L634-
A.02.26

To: After Sales Official Network
Subject: Sound symposer covered
Date: 25/05/2026
Pages: 4

Campaign name:
Sound symposer covered

Model:
Temerario

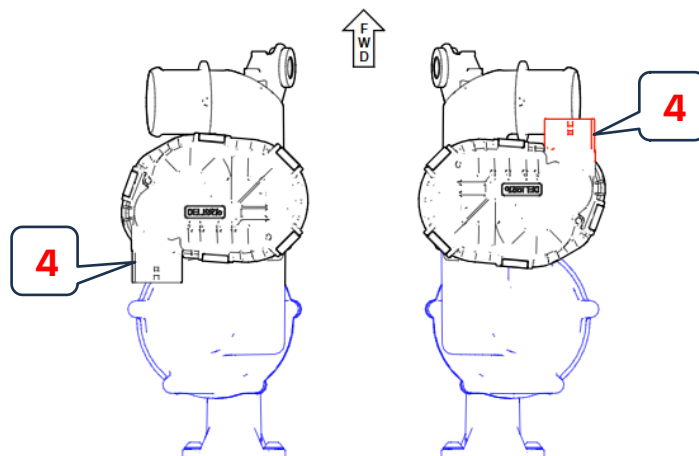
3. With the Sound Symposer group on bench, unscrew the two TP6X45 screws (1), remove the Sound Symposer connector (2) and position the closing plate (3) between the connector (2) and the valve (4).

4. Secure the Sound Symposer connector (2) using the two TP6X45 screws (1).

Pre-tightening torque: 4.0 Nm (2.95 lbf ft)

Tightening torque: 7.0 Nm (5.16 lbf ft)

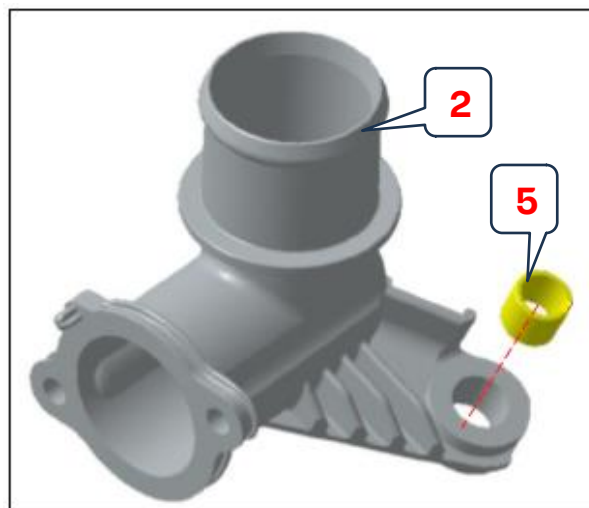
5. During installation, be sure to check that the valve connections (4) are facing in the correct direction.

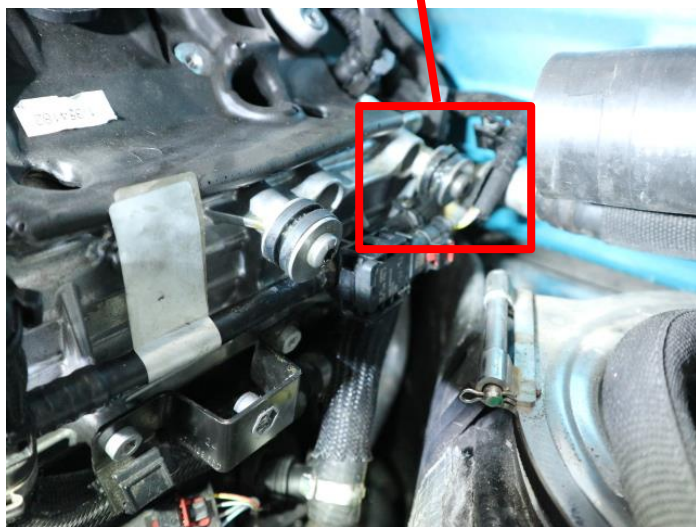
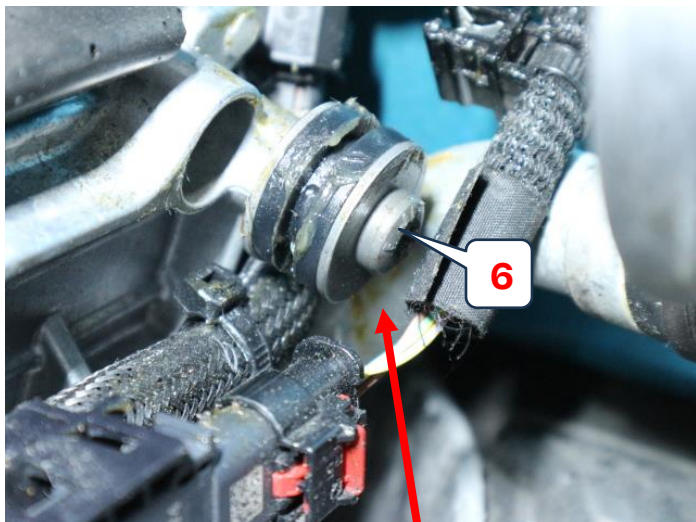
6. Before reinstalling the Sound Symposer in the vehicle, replace the bushings (5) with the new ones (code 07N129227) on the fixing connector (2).

7. To replace the bushing (5), unscrew the M6x25 screw (6) and remove the seal together with the bushing and its washers. Then replace the bushing (5). Refit the seal with the new bushing and its washers, and secure them with the M6x25 screw (6).

Tightening torque: 8.00 Nm (5.90 lbf ft) $\pm$ 10%
